## **Planning Board – Monday, December 21, 2020, 6:30PM**

### **AGENDA**

## **SPR-878, Modification #1 –SITE PLAN REVIEW – Addition to Noyes Volkswagen, 18 Production Avenue**

**PROPOSED PLAN**

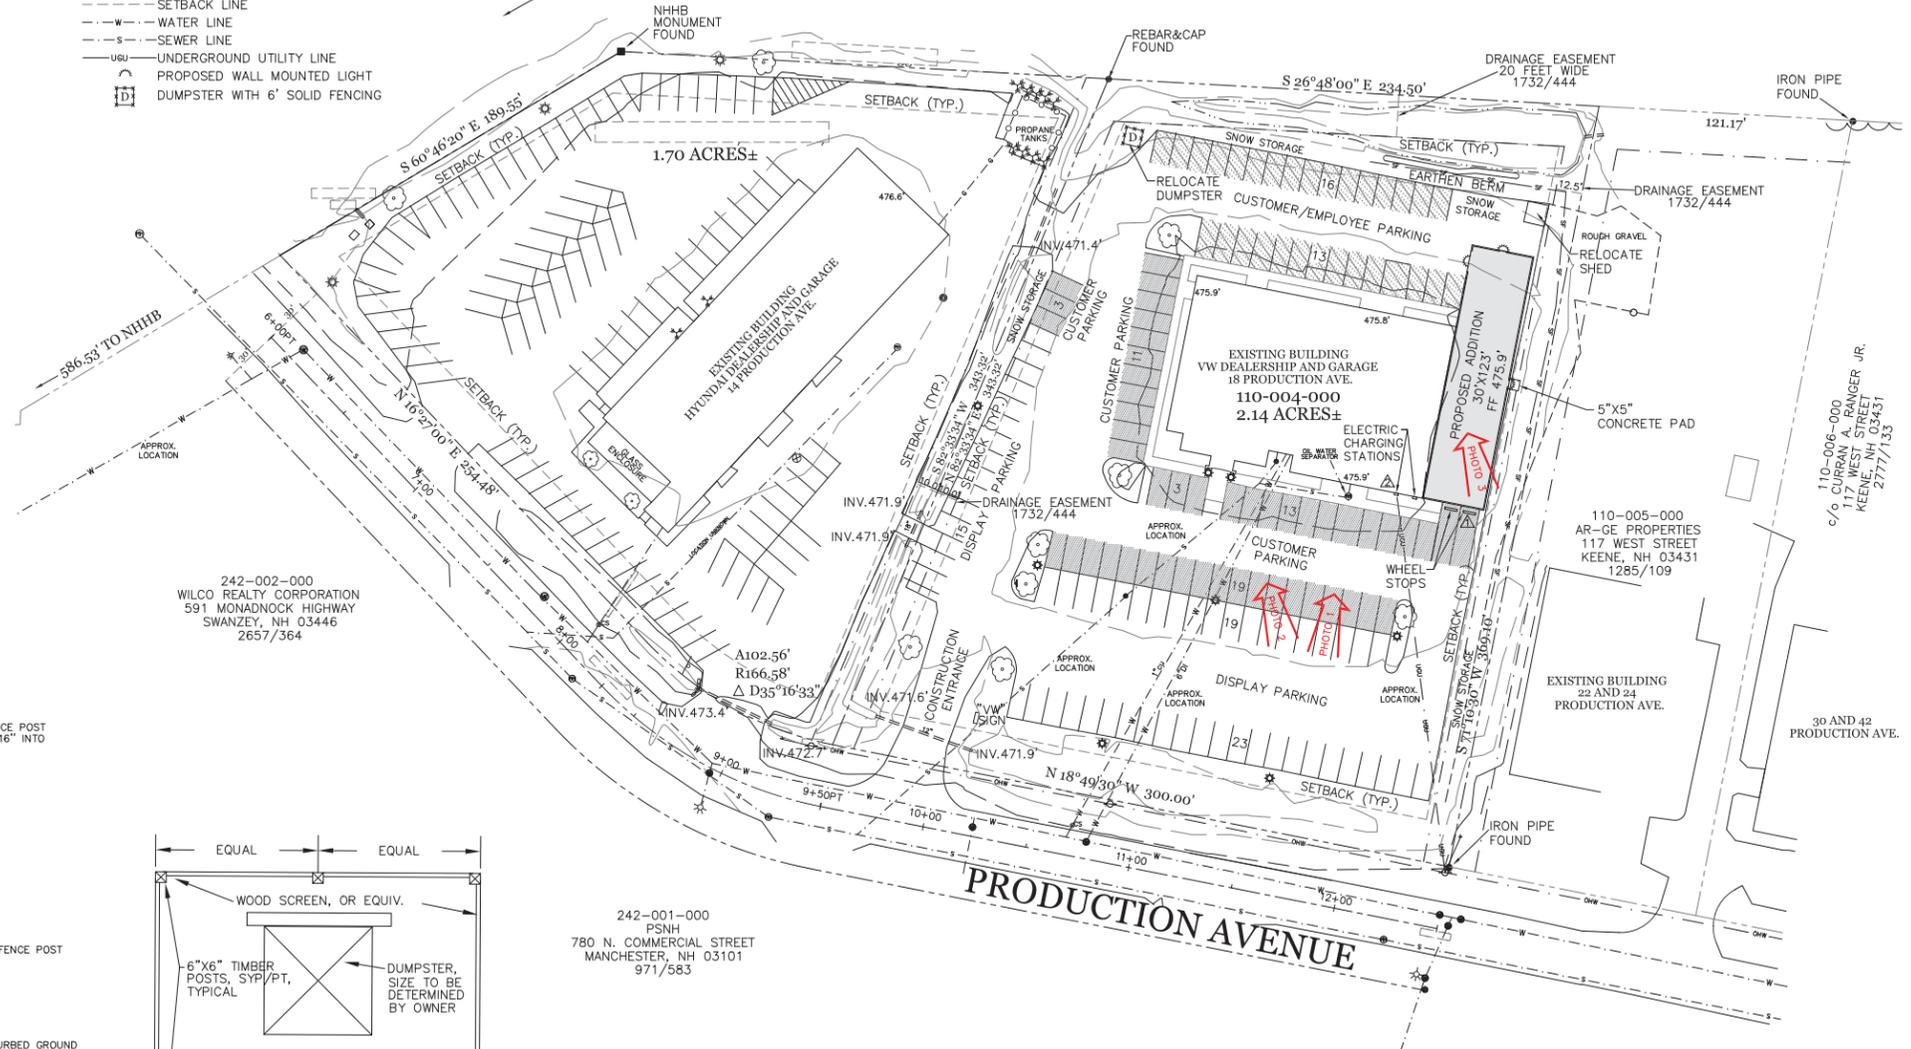
2. **Sedimentation and Erosion Control:** The Applicant proposes to install silt fencing to the south and east of the area to be disturbed. A detail for silt fencing is included on the proposed site plan. This standard appears to be met.

8. Screening: The Applicant proposes to relocate the existing dumpster and screen it with a 6' high solid wood fence. A detail for the dumpster screening is included on the proposed site plan. This standard appears to be met.

## LANDSCAPE PLAN

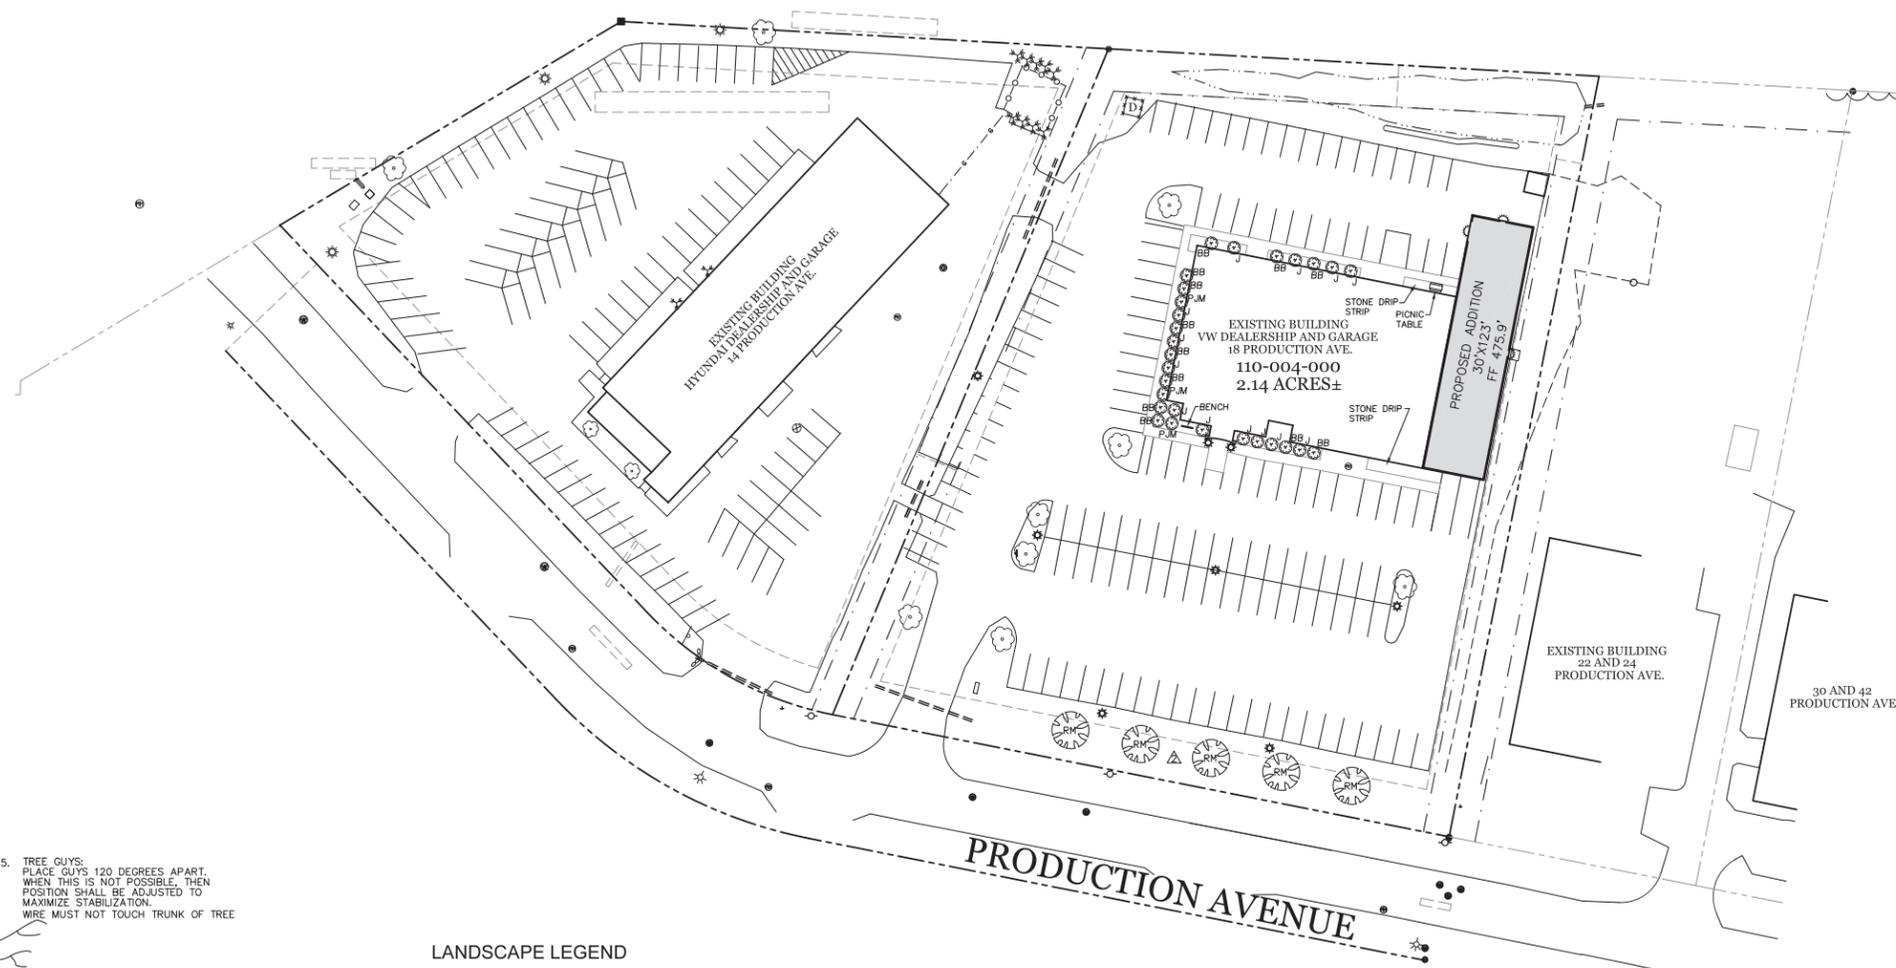
5. **Flooding:** This property is not located within the 100-year floodplain. This standard does not apply.
6. **Landscaping:** The Applicant proposes to modify the landscaping plan that was originally approved in 2000 as part of SPR-878 to reduce the total number of shrubs and trees on the site. In the project narrative, the Applicant notes that the landscaping has matured over the past 20 years, and although there are fewer plants around the building, these plants fill up the landscaping areas around the building. In addition, the Applicant proposes to replace five Norway maples along Production Avenue which have died with five Red maples. The table below compares the number of plants and trees that were approved in 2000, and the number of plants and trees that are currently proposed. Staff recommend that submittal of a security for landscaping be included as a condition of approval to ensure that the five new trees survive one year.

This standard requires one tree for every ten (10) parking spaces in parking lots of 10 spaces or more. The Applicant proposes to replace five trees that have died, for a total of 12 trees on the site. There are 75 parking spaces for employee and customer parking, and an additional 60 parking spaces for display only (a total 135 parking spaces). Staff recommend that the display parking spaces should not count towards the total number of parking spaces for the purposes of this standard due to their intended use as display parking.
